Project	<b>IEEE 802.16 Broadband Wireless Access Working Group</b> < <a href="http://ieee802.org/16">http://ieee802.org/16</a> >	
Title	<b>Idle Mode Backbone Procedures</b>	
Date Submitted	<b>2005-03-11</b>	
Source(s)	Beomjoon Kim, Kiseon Ryu, Aeran Youn LG Electronics Inc. LG R&D Complex, 533 Hogye-1dong, Dongan-gu, Anyang, 431-749, Korea	Voice: +82-31-450-7188 Fax: +82-31-450-7912 <a href="mailto:beom@lge.com">[mailto:beom@lge.com]</a>
Re:	Call for Comment on P802.16g Baseline Document	
Abstract	This contribution proposes backbone procedures to support Idle Mode	
Purpose	To be discussed in Legacy Messages Ad-Hoc, IEEE802.16g	
Notice	This document has been prepared to assist IEEE 802.16. It is offered as a basis for discussion and is not binding on the contributing individual(s) or organization(s). The material in this document is subject to change in form and content after further study. The contributor(s) reserve(s) the right to add, amend or withdraw material contained herein.

## Idle Mode Backbone Procedures

Fig. 1 Idle Mode Initialization

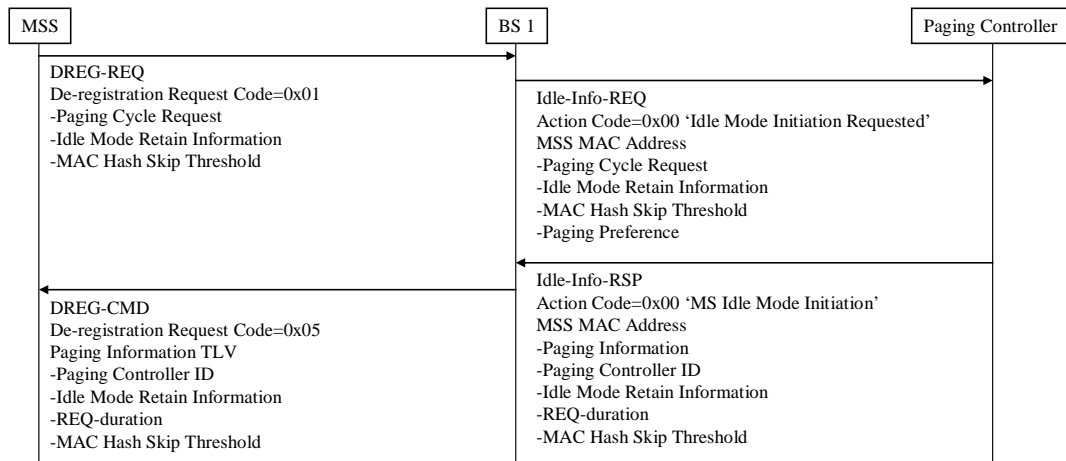
When serving BS receives a DREG-REQ message with De-registration Code=0x01, 'request for De-Registration from serving BS and initiation of Idle Mode', BS shall transmit to Paging Controller Idle-Info-REQ message with Action Code = 0x00, 'Idle Mode Initiation Requested'. If the DREG-REQ message includes TLV parameters such as Paging Cycle Request, Idle Mode Retain Information, and MAC Hash Skip Threshold, then the BS shall deliver all the parameters to Paging Controller. In addition, BS may include Service Flow management encodings such as Paging Preference TLV in Idle-Info-REQ message.

If Paging Controller approves MS Idle Mode Initialization, then Paging Controller shall respond to serving BS by sending Idle-Info-RSP message with Action Code = 0x00, 'MS Idle Mode Initiation'. In the Idle-Info-RSP message with Action Code = 0x00, Paging Controller shall include Paging Information, Paging Controller ID, and Idle Mode Retain Information, and may include MAC Hash Skip Threshold and REQ-duration. Paging Controller may send the Idle-Info-RSP message to notify other BS of MS Idle Mode Initiation.

Fig. 2 Paging Procedures for DL traffic

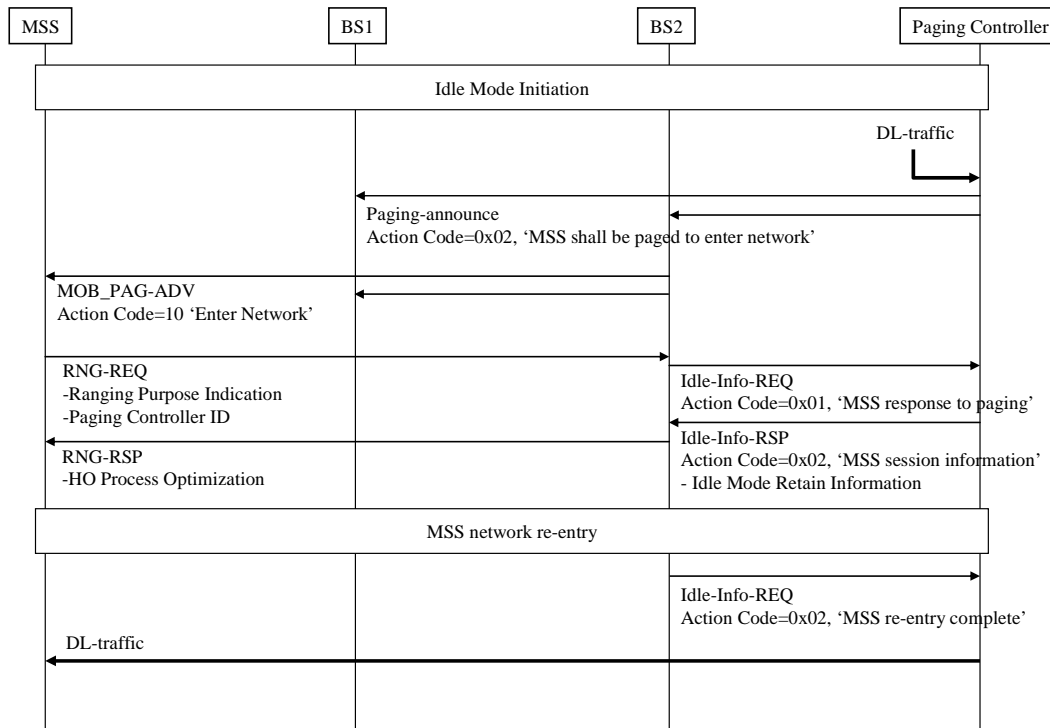
If DL traffic to MS in Idle Mode arrives at Paging Controller, then Paging Controller shall transmit Paging-announce message to all BSs belonging to the paging group where the MS is supposed to stay with Action Code= 0x02, 'MS shall be paged to enter network'. BS receiving the Paging-announce message shall broadcast MOB\_PAG-ADV message as specified in 6.3.21.7.

If BS receives RNG-REQ message including Ranging Purpose Indication TLV with setting bit #0 to 1 in combination with Paging Controller ID, it shall notify Paging Controller of MS response to paging through Idle-Info-REQ message with Action Code=0x02. Paging Controller may provide a new serving BS with MS service and operational information and Idle Mode Retain Information through Idle-Info-RSP message with Action Code=0x02.

After MS's re-entry, BS shall notify Paging Controller of MS successful re-entry through Idle-Info-REQ message with Action Code=0x02. Paging Controller may notify other BS of MS Idle Mode Termination by transmitting Idle-Info-RSP message with Action Code = 0x01.
